18 April 2019

Viva Energy Clyde Conversion Project: SSD 5147 Modification 1 - Response to Submissions

Figure 1 Trees proposed for removal to demolish the State Office Building

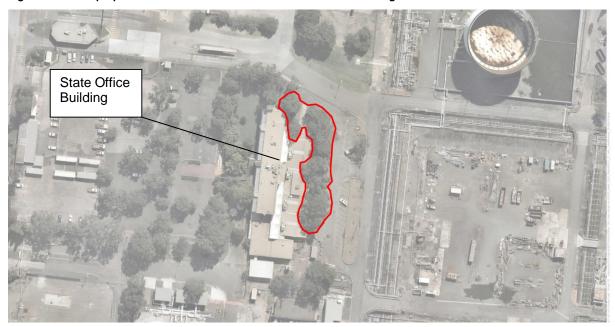
The Council noted that the modification application stated that there is a need for tree removal but provided no details on the extent of tree removal or nature of the trees to be removed. It was the view of the Council that "approval should not be granted without details of the tree removal as a proper assessment of their removal cannot be appropriately undertaken." CPC stated that "an Arboricultural Impact Assessment (AIA) and Tree Protection Plan (TPP) prepared by an AQF Level 5 arborist must be provided for assessment." The comment went on to outline the information that should be provided with the AIA and TPP.

Nevertheless Viva Energy has reviewed the works required at the State Office Building and can confirm that up to 31 trees are likely to be removed to allow the structure's demolition to take place. The removal of these trees is required to allow safe access to the State Office Building for its proposed demolition. Please note that the demolition of this building is only down to grade and does not involve excavation.

The trees that require removal are listed in Table 1. These trees are located to the east and north of the State Office Building (refer to Figure 1 below). These trees were inspected by a suitably qualified and experienced ecologist to confirm their species and other key characteristics.

The trees proposed for full removal include a range of commonly planted landscaping species. None of these are listed as threatened in NSW and none of the trees were found to contain substantial habitat such as hollows, though it is noted that these individuals would provide casual habitat value for mobile species such as birds. The only fauna observed utilising these trees during the site visits were noisy miner and Australian raven.

No other works (pruning etc.) are proposed to any trees that would be retained. Existing mitigation measures in place for the protection of flora outline measures to protect vegetation that is to be retained through the use of, for example, signage, barrier fencing and tree guards,
